# **Mt Walton integrated waste disposal facility Environmental Management Programmes**

**Health Department of Western Australia**

**Evaluation by the  
Environmental Protection Authority**

**Environmental Protection Authority  
Perth, Western Australia  
Bulletin 571  
August 1991**

Figure 1. Locality map and transport routes (adapted from EMP)

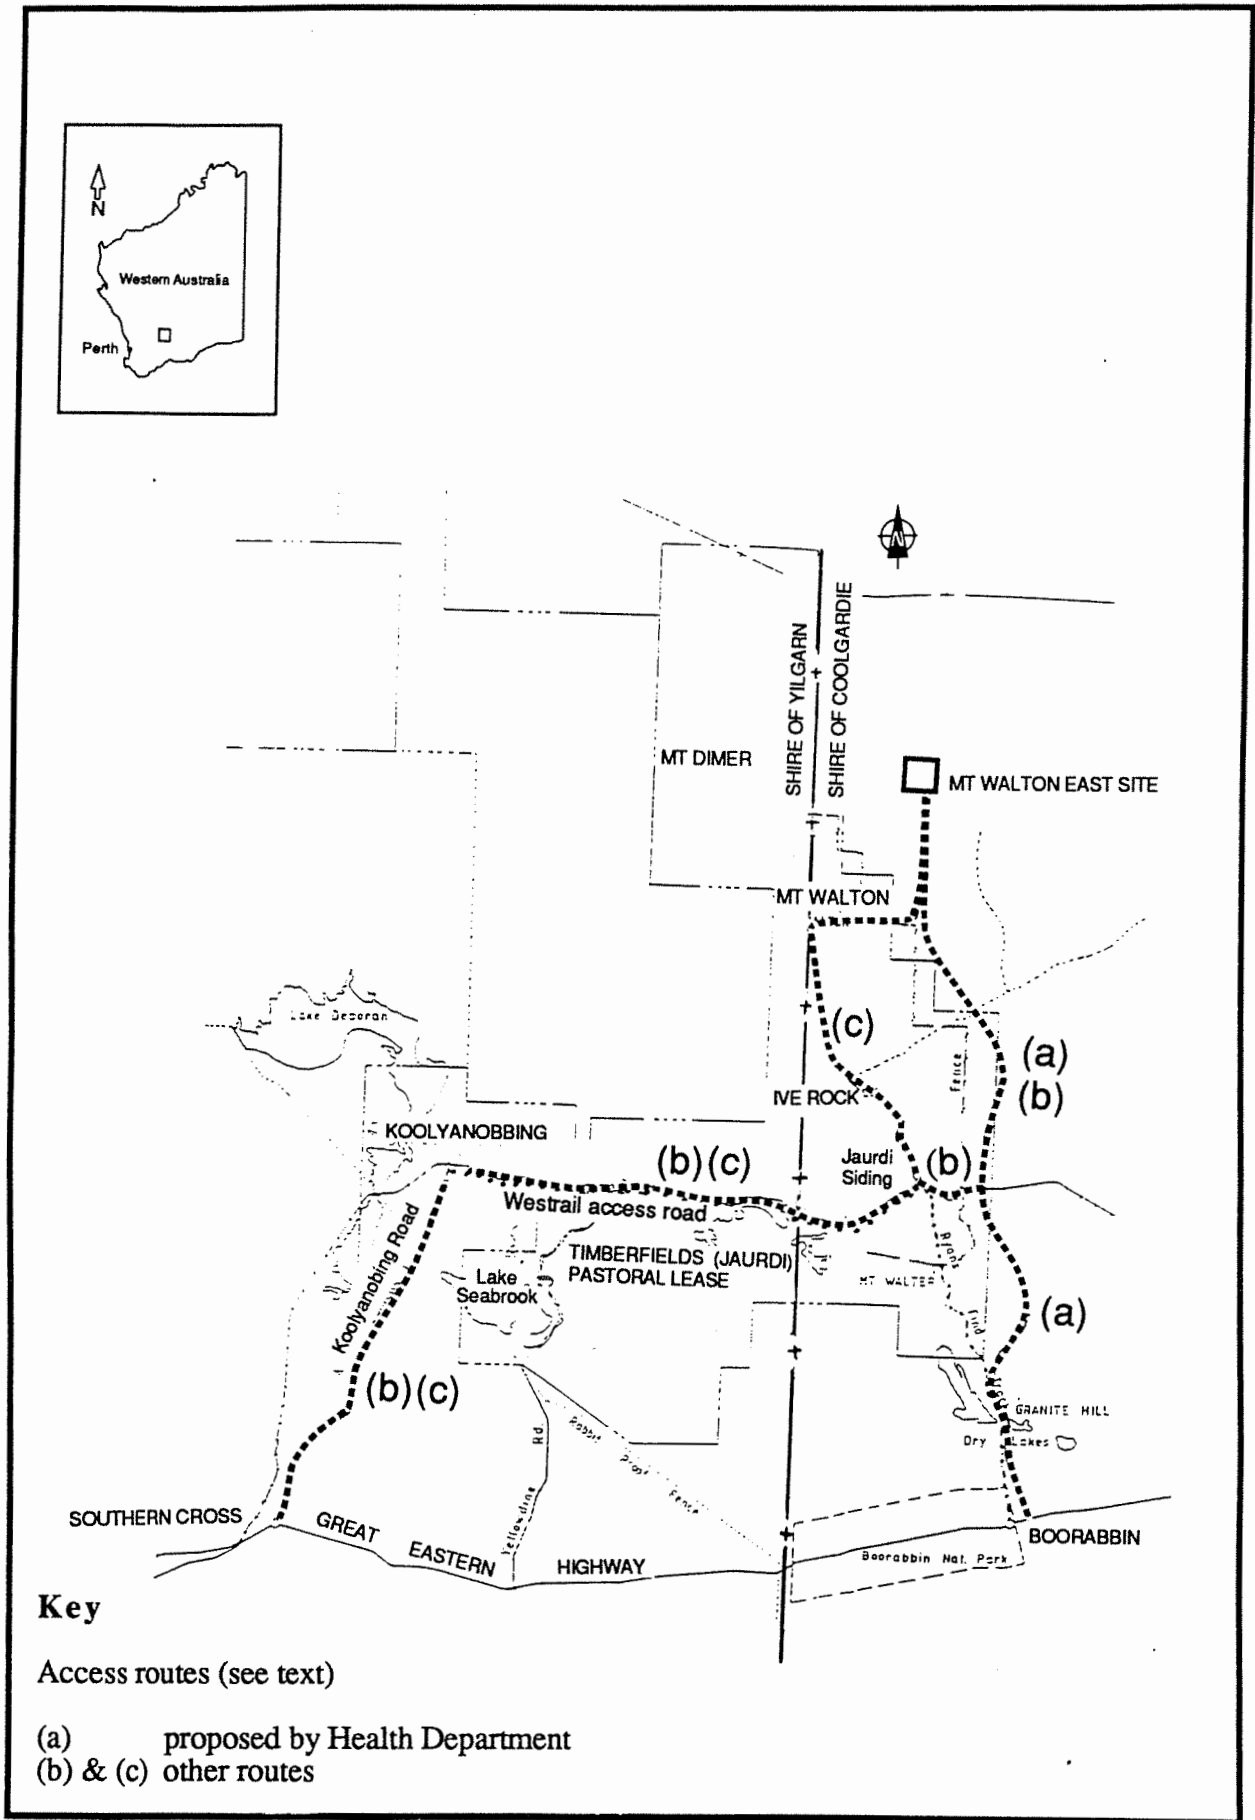
Given that the total quantity of waste currently identified comprises less than 600 tonnes (which the proponent estimates could require 30 truck loads, but no more than 100 truck loads), the Environmental Protection Authority considers that there are several possible access routes, all of which are environmentally acceptable. These options, which are shown in Figure 1, are:

- (a) access route proposed by the Health Department from Boorabbin on the Great Eastern Highway to the site;
- (b) utilise the Westrail access road from Koolyanobbing eastwards to the existing trace, and then north to the site; and
- (c) utilise the Westrail access road from Koolyanobbing eastwards, and then through the Reserve managed by the Department of Conservation and Land Management, from Jaurdi to the site.

The Environmental Protection Authority considers that given the limited amount of waste, the limited number of vehicles required would not cause environmental damage to the Jaurdi Pastoral Lease should this be the preferred route (route (c) above). Appropriate action would have to be taken to ensure that the existing track is not degraded, and to minimise any damage to flora adjacent to the tracks in the reserve.

The Environmental Protection Authority also considers that access roads (whichever route is used) should not be upgraded to all-weather roads which would attract people into the area. Instead, the roads should be of a standard sufficient only to enable a limited number of trucks to pass in good weather.

The Environmental Protection Authority finds that all of the above access routes to the site are environmentally acceptable subject to a botanical survey being carried out for the route chosen, prior to any upgrading of access.
